Planning Officer Assessments  
Housing Delivery Authority  
Department of Planning, Housing and Infrastructure  
Reply by portal: <https://majorprojects.planningportal.nsw.gov.au>

**SSD-89869959 10 Dangar Street Wickham NSW 2293**  
**EIS Public Submission**

Figure 2 - Extract from Wickham Public Domain Plan (2023, p.36)

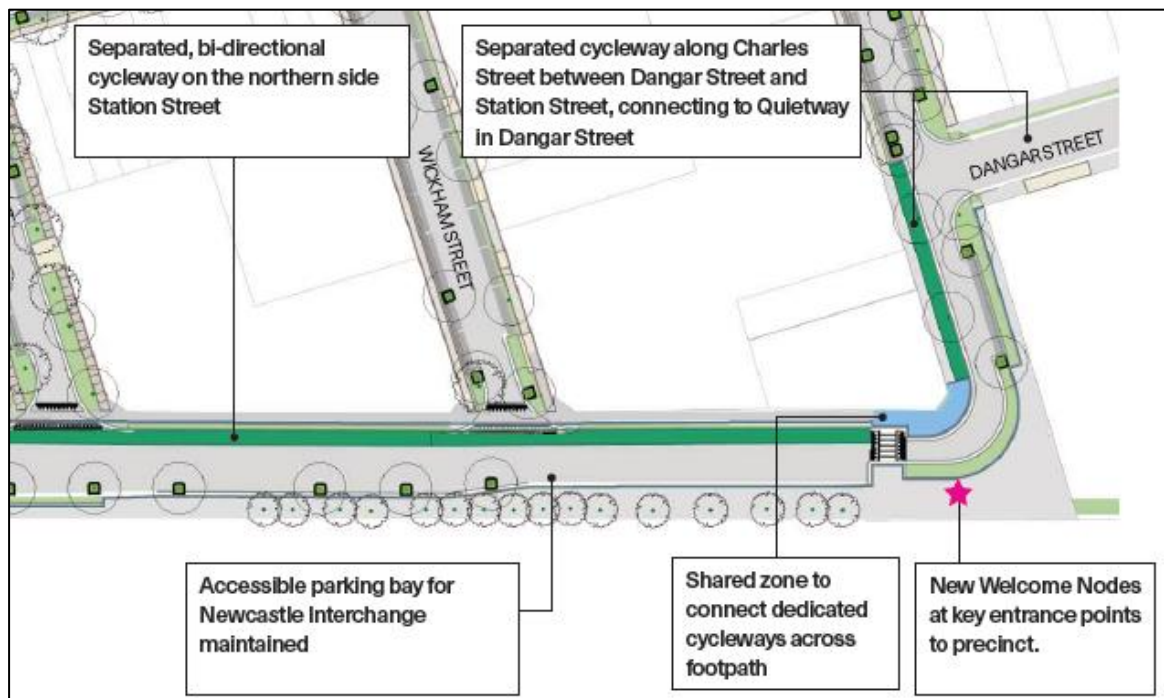
- The Wickham Public Domain Plan no long includes Project #12 or any other community infrastructure on the proposed site. It now has an on-road cycleway from Dangar Street to Wickham Park via Station Street as shown in Figure 2 (p.7 below).

The concept shown above in the Wickham Public Domain Plan has not undergone community consultation; it was added after community consultation. Considerable improvements are envisaged; see section on public domain.
